Access Compliance Report

Public Rights-of-Way

(Curb Ramps)

Intersection ID: 10027126	Main Street: GARDEN_TR	Cross Street: N/A	Location: E
ADA ID: 4F5F820FE325	Ramp Type: Perp	Initial Pass/Fail: Fail	Overall Compliance: No
		Severity Score: 12.5

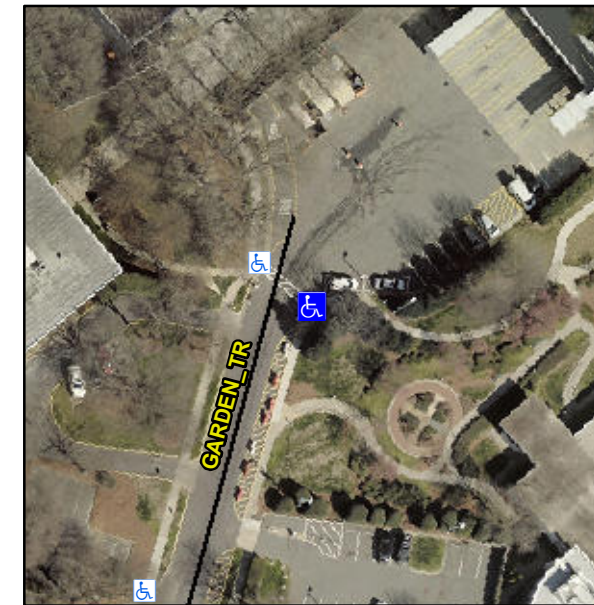
R304.5.3

Compliance	Description	Data	Compliance	Description	Data
N/A	Ramp Length (in)	64.0	Yes	Ramp Slope (%)	8.0
Yes	Ramp Width (in)	50.0	No	Ramp XSlope (%)	5.8
N/A	Flare Type LT	N/A	N/A	Flare Type RT	N/A
N/A	Flare Slope LT (%)	N/A	N/A	Flare Slope RT (%)	N/A
N/A	Flare Traversable LT?	N/A	N/A	Flare Traversable RT?	N/A
N/A	Landing Length (in)	N/A	N/A	DWS Provided?	N/A
N/A	Landing Width (in)	N/A	N/A	DWS Contrast?	N/A
N/A	Landing Slope (%)	N/A	N/A	DWS Length (in)	N/A
N/A	Landing X Slope (%)	N/A	N/A	DWS Full Width?	N/A
N/A	Landing Curb? (Y/N)	N/A	N/A	DWS Offset (in)	N/A
N/A	Shared Landing?	N/A			
N/A	Gutter Ponding?	N/A	N/A	Gutter Slope (%)	N/A
N/A	Gutter Lip Ht (in)	N/A	N/A	Gutter X Slope (%)	N/A
N/A	Painted X Walk1?	Yes	N/A	Painted X Walk2?	N/A
	X Walk 1 Direction	To NW		X Walk 2 Direction	N/A
N/A	X Walk 1 Width (in)	45.0	N/A	X Walk 2 Width (in)	N/A
	X Walk 1 Slope (%)	3.1		X Walk 2 Slope (%)	N/A
	X Walk 1 X Slope (%)	5.0		X Walk 2 X Slope (%)	N/A

Remove & Replace Entire Ramp.
